APPROVED MEETING MINUTES

September 1, 2016

Judkins Park Station

The purpose of this meeting was to review the design development proposal for the Judkins Park Light Rail Station. After the presentation and discussion, the Light Rail Review Panel (LRRP) voted 7 to 1 to approve the design development for Judkins Park Light Rail Station with several conditions and recommendations. This is the last time the LRRP will review the project.

Figure 1: Proposed west entry (top & middle) and east entry (bottom)

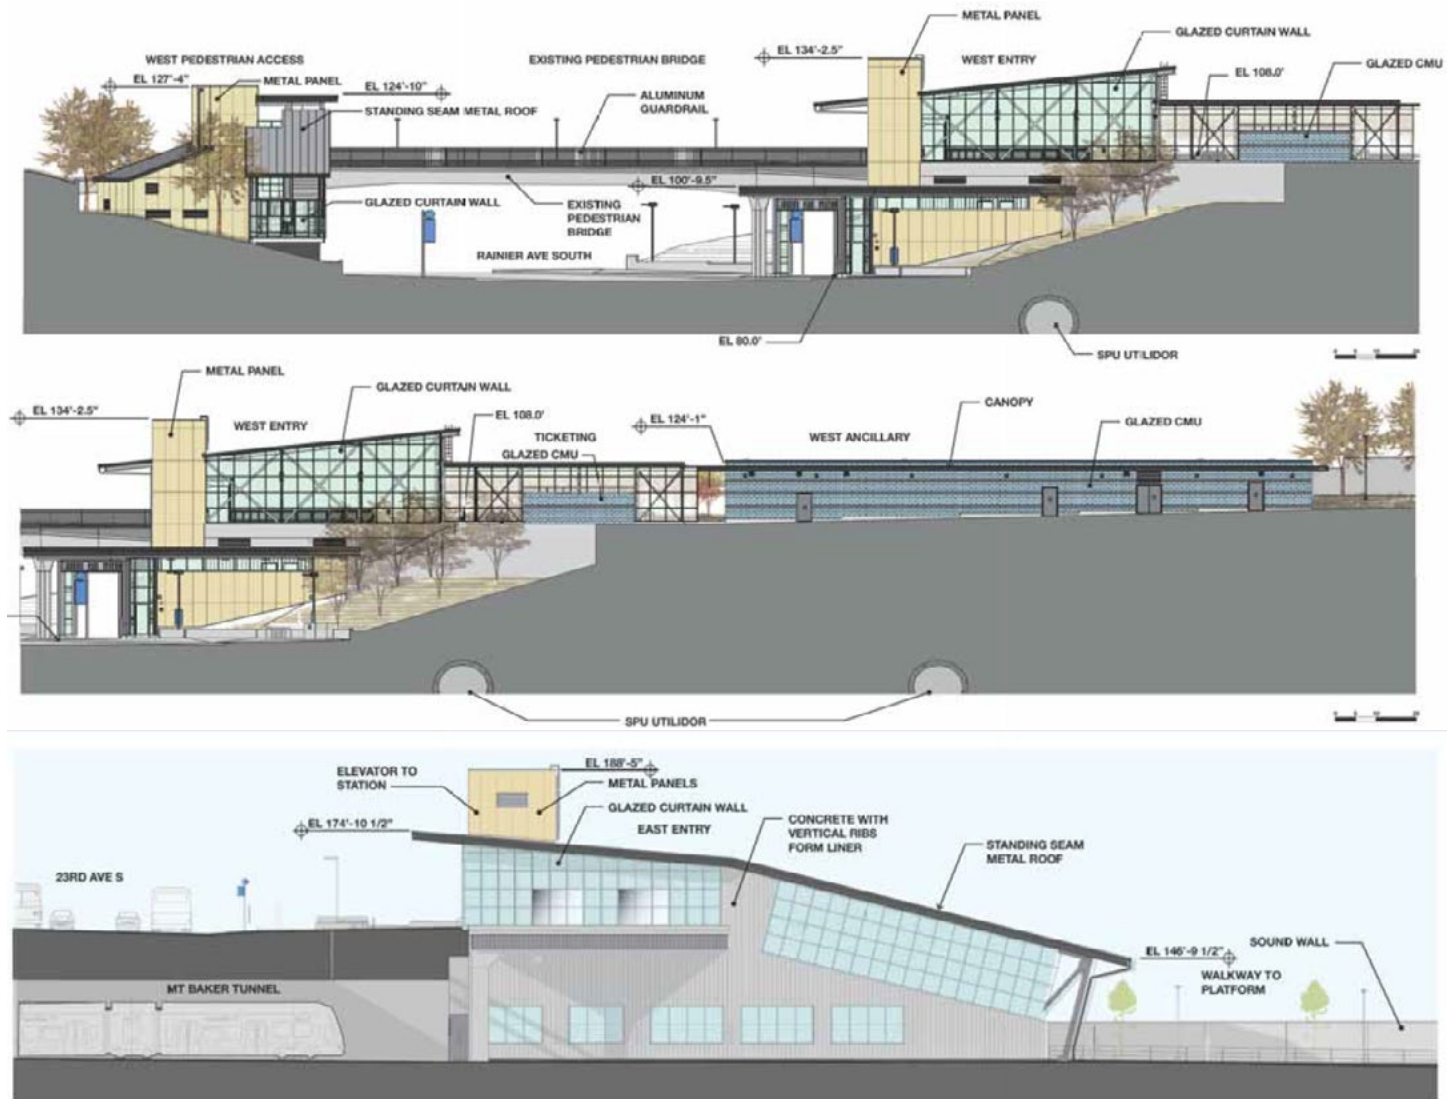
The LRRP is concerned with the design of the east entrance along Rainier Ave S. Specifically, the LRRP is concerned with the bulkiness of the new proposed entry canopy, which appears more dominant than the surrounding facilities including the proposed artwork located on the entrance façade behind the gateway entrance. The LRRP recommended the project team refine the entry canopy design to reduce its dominance in relation to the surrounding station facilities. The LRRP also recommended the entry canopy be located as close to the station entrance as possible in order to reduce its presence within the ROW along Rainier Ave S.

1. Continue the refinement of the west entry canopy design on the east side of the Rainier entrance as it relates to:
 - Minimizing the protrusion of the entry canopy within the sidewalk area along Rainier Ave
 - Enhancing the visual prominence of the artwork proposed on the elevator façade
 - Minimizing the heaviness of the entry canopy structure to allow for more light; emphasizing the verticality found throughout the project design
